## REMARKS

Title: LASER DIODE AND METHOD OF MANUFACTURING  
THE SAME USING SELF-ALIGN PROCESS

Appln. No.: 10/813,157

FIG. 4A

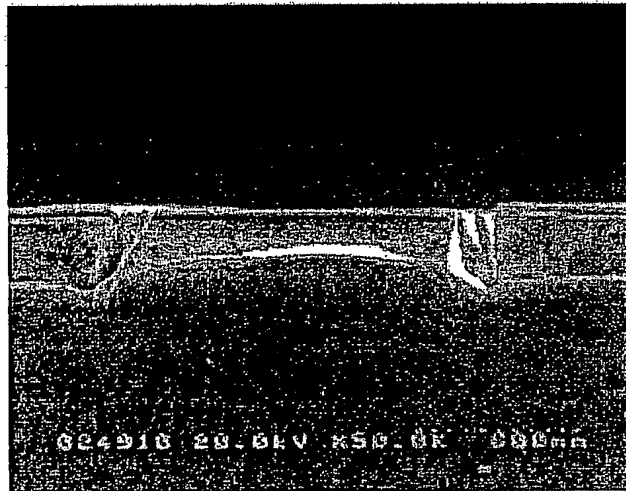
The attached drawing sheet includes changes to Fig. 4A. This sheet replaces the original sheet that includes Fig. 4A. In Replacement Sheet 1, Fig. 4a was amended to include a "Prior Art" legend.

On page 2 of the Office Action, the Patent Office suggested that Figure 4a be designated by a "Prior Art" legend. Applicants appreciate this suggestion and have amended Figure 4a accordingly.

*Prior Art*
